**EXPERIMENTAL ROAD CLOSURE,
BALFOUR ROAD, LB MERTON**

**STAGE 1/2 - ROAD SAFETY AUDIT
NOVEMBER 2015**

Location of Identified Problems

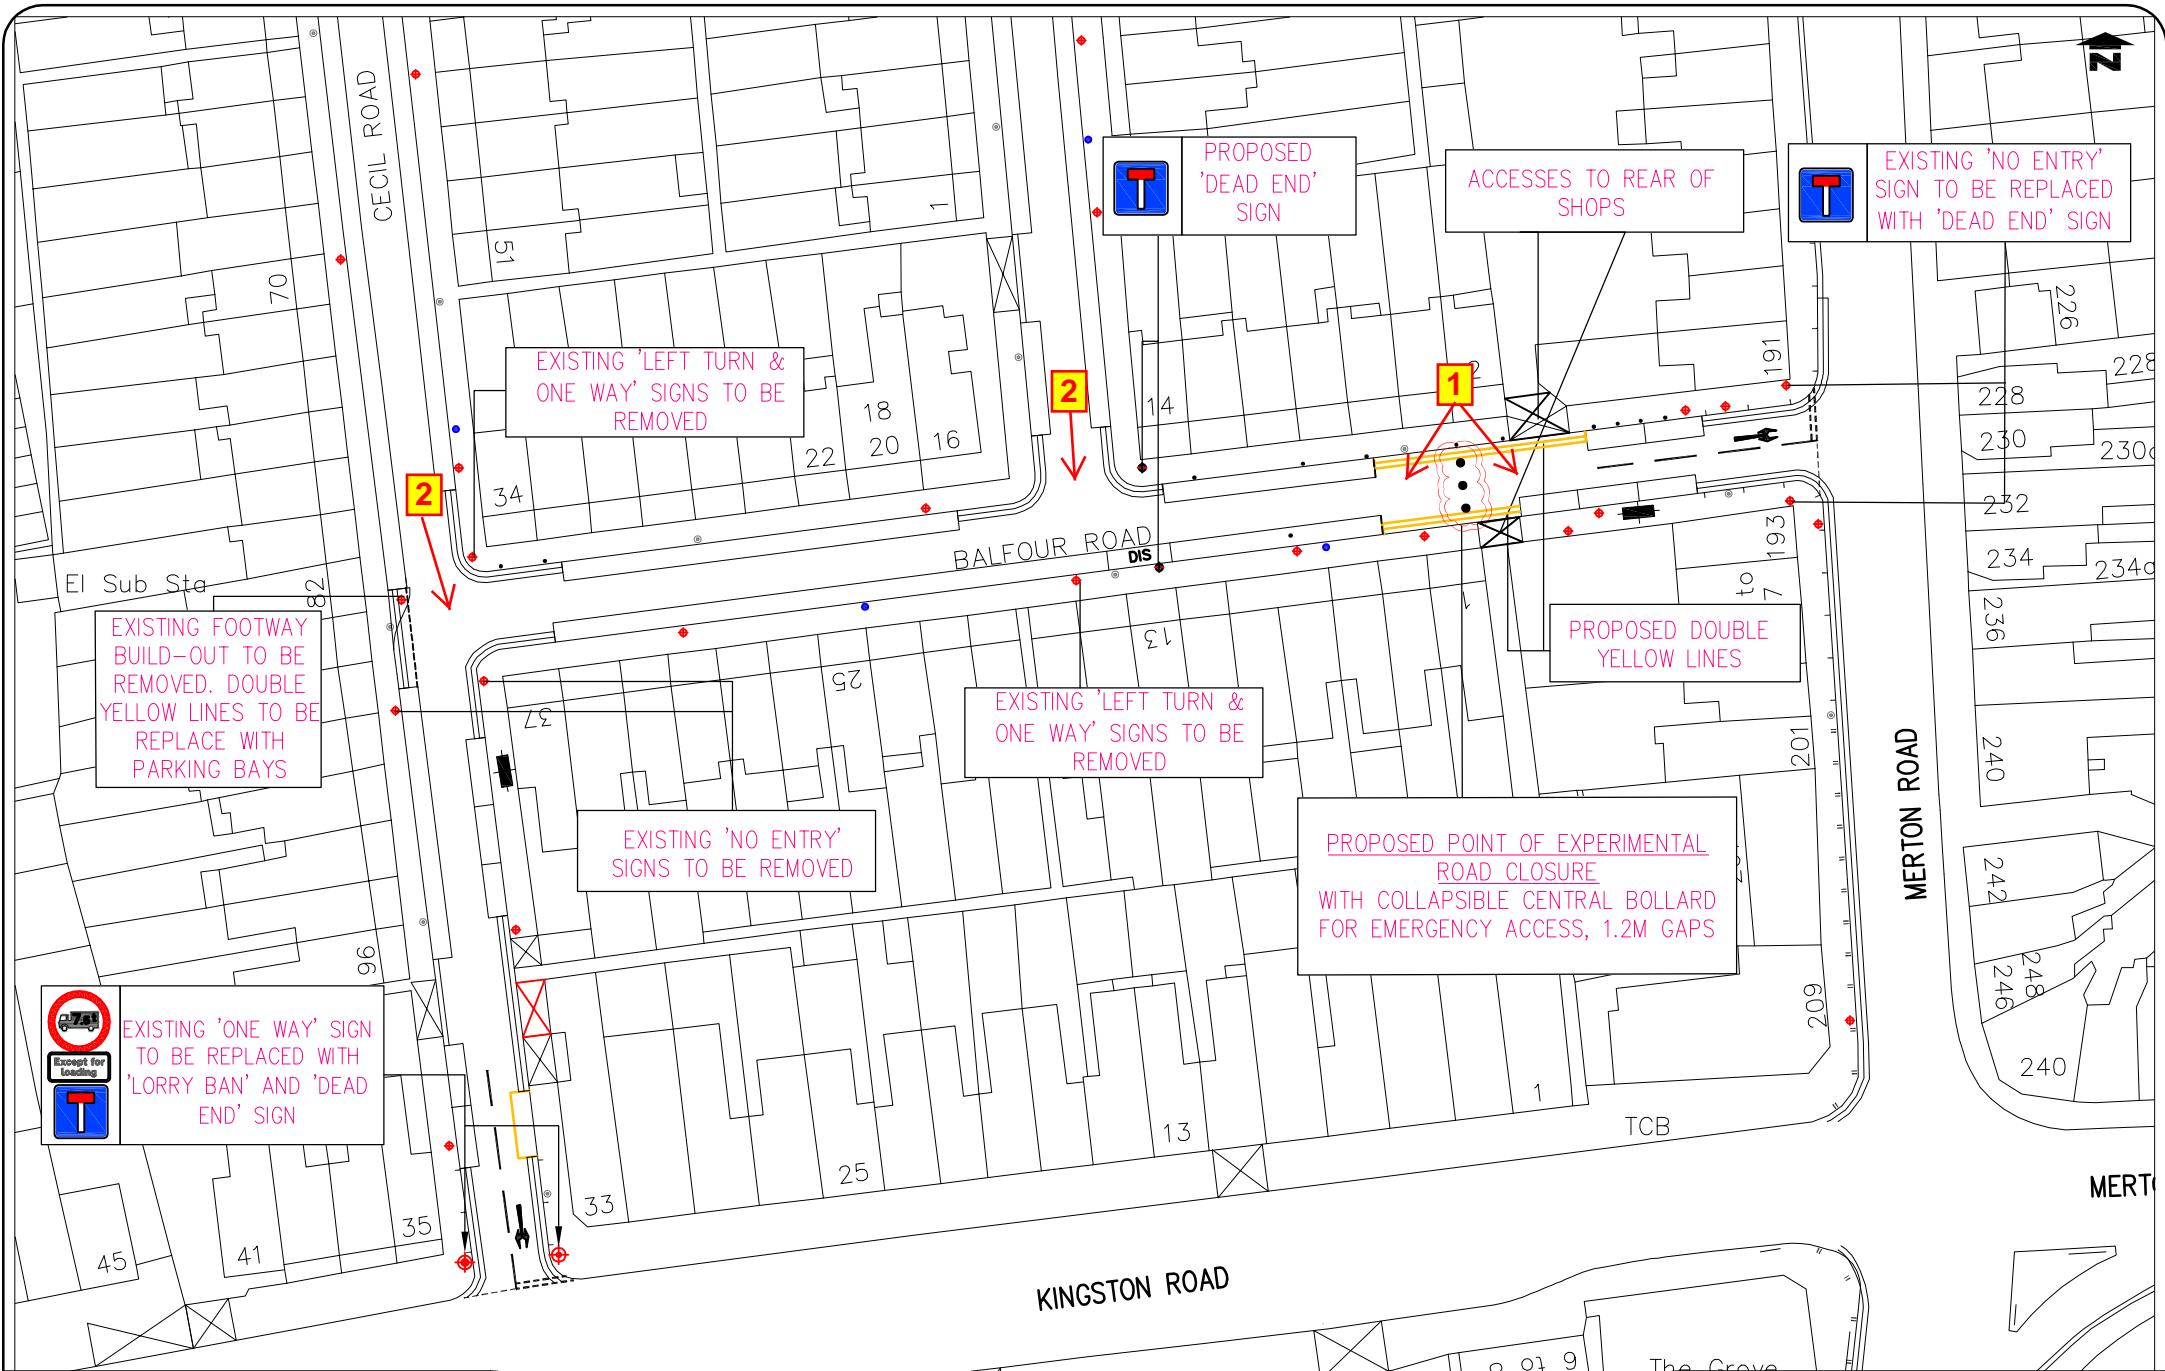
LOCATION: Balfour Road.

SUMMARY: Potential lack of sufficient turning provision.

- 2.1 The introduction of the bollards may result in there being insufficient turning provision adjacent to the bollards for a significant number of users including residents especially those parked within the parking bays adjacent to the bollards, potential HGVs/MGVs associated with the commercial premises or refuse vehicles either side of the bollards. This issue may result in injudicious turning and/or reversing manoeuvres over an excessive distance that may lead to a number of road safety issues at this location including:

- Vehicles having to reverse onto Merton Road into the path of on coming traffic which could include HGVs/MGVs associated with the commercial premises accessed from Balfour Road;

- Vehicles having to reverse onto Cecil Road (east) which may result in increased levels of conflict at this junction; and
 - Potential multi-point turning manoeuvres where a sufficient turning head is not provided.

- 2.2 It is considered that all of the above issues would potentially result in increased highway safety risks that could result in collisions involving vehicles or vehicles and pedestrians.

- 2.3 It is also noted that the area adjacent to the bollards where vehicles would be required to turn is adjacent to a nursery which may exacerbate the problems identified above and potentially increase the risk of vehicular collisions with vulnerable road users.

LOCATION: Balfour Road junctions with Cecil Road.

SUMMARY: Lack of give way road markings.

- 2.6 At both the Balfour Road (east) and Balfour Road (west) junctions with Cecil Road there are no details provided with regard to the give-way road markings at these locations. A lack of appropriate road markings at these locations could lead to side-swipe type collisions at these locations. It is noted that give way road markings are currently provide at both junctions, albeit that they are extremely worn at the Balfour Road (east)/ Cecil Road junction.

- RECOMMENDATION**
- 2.4 Ensure suitable turning facilities are provided for vehicles to safely turn either side of the bollards.
- 2.5 It is noted that double yellow lines are provided in advance of the bollards which allows for increased width for turning vehicles, however vehicle swept path analysis should be

undertaken using the largest vehicle size anticipated to use Balfour Road to ensure the layout is satisfactory with regard to the problem raised.

- 2.7 Ensure give-way road markings are provided at both the Balfour Road (east) and Balfour Road (west) junctions with Cecil Road.
